From: Wilson, Keith
Sent: Friday, December 19, 2003 11:38 AM
To: Walker, Kay
Subject: Place of use 13-7057

From: Walker, Kay
Sent: Friday, December 19, 2003 12:24 PM
To: Wilson, Keith
Cc: Walker, Kay
Subject: License 13-7057

Map #1 - As shown on Examiners aerial photo

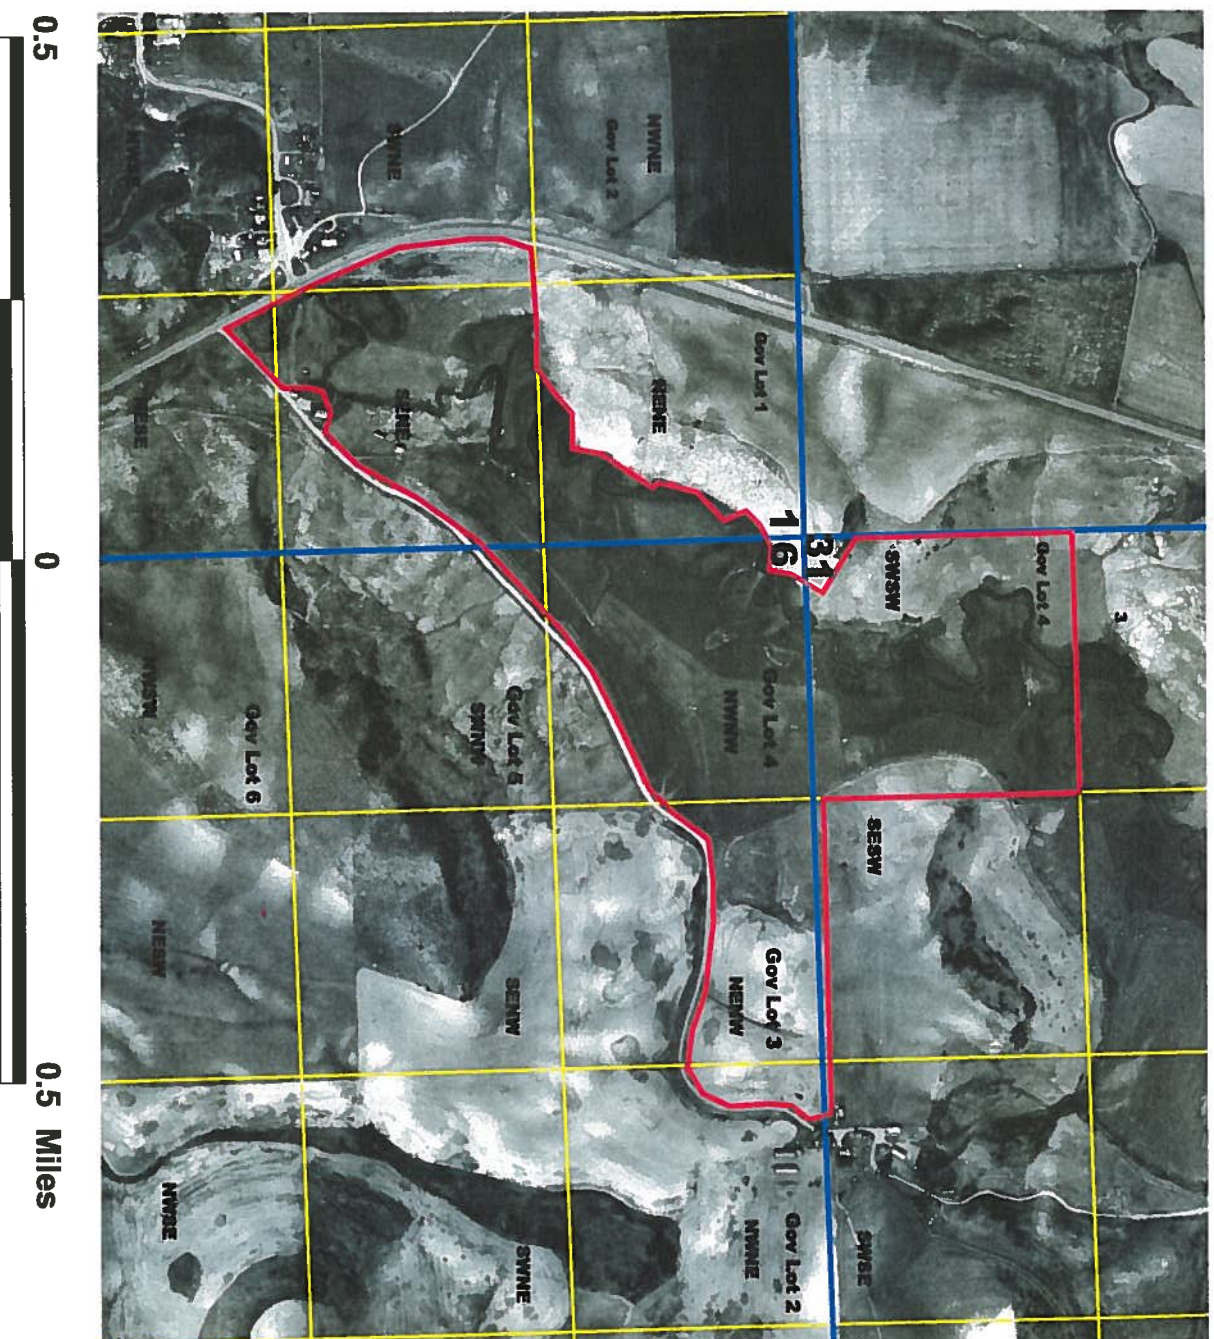
Kay,
While working on another water right I could not determine the place of use for 13-7057 so I looked in the microfiche. The map is not very good but from what I could see it appears that the place of use is incorrect in Sec 6, T12S, R41E. I drew what appeared to be on the map as ground irrigated by 13-7057. Could you look at the vault file to determine exactly what the place of use actually is?

Is the place of use in the N1/2NE1/4, and W1/2NW1/4 Sec 6, and not also in the NENW Sec 6?

Hi, Keith... Got your message about this license and you are quite right. The place of use is licensed in error. The lands shown in T12S, R41E, S06 should be shown as this:

NWNE - 2 ACRES
NENW-19 ACRES
NWNW- 35 ACRES
SWNW - 2 ACRES

I have made a correction to the shape you created so that it matches the land identified on the map. Attaching the corrected shape for you to see what the map shows.
